File No: R/2020/6/B  
Our Ref: 2021/187303

**Response to RtS – Waterloo OSD Southern Precinct – SSD 10437**

## Attachment A – Response to RtS

#### Awnings

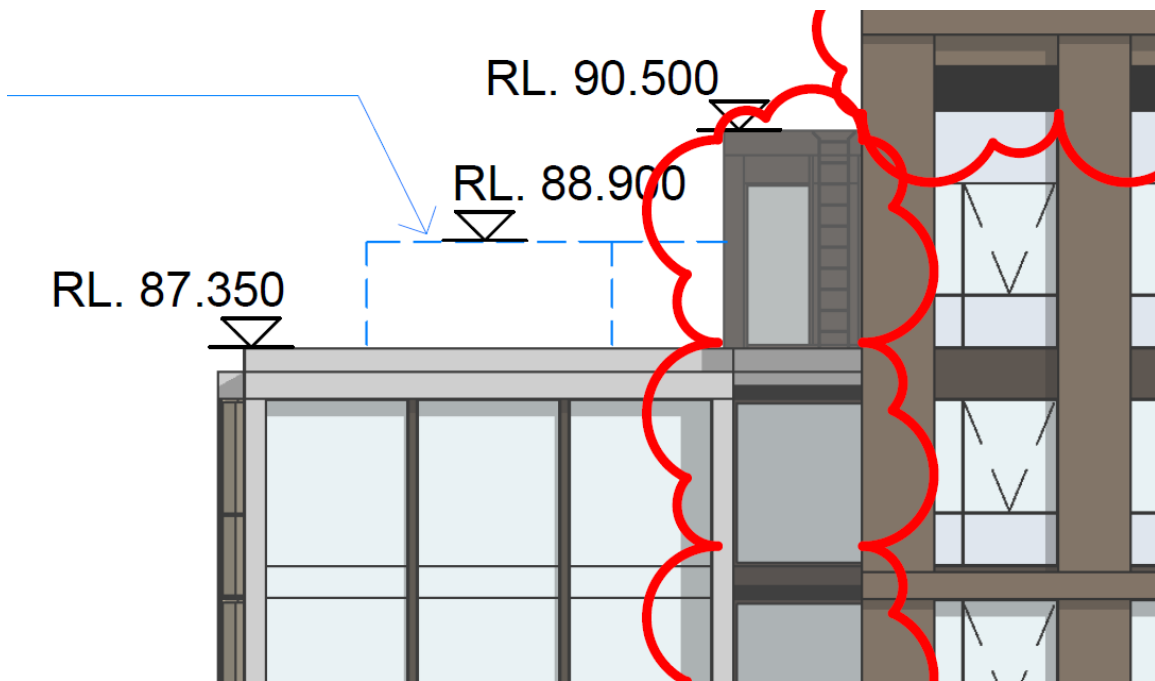
14. Awnings located over the footpath and adjacent at grade spaces should by way of condition comply with the Section 3.2.3 of the Sydney Development Control Plan 2012 to provide weather protection and amenity to pedestrians.
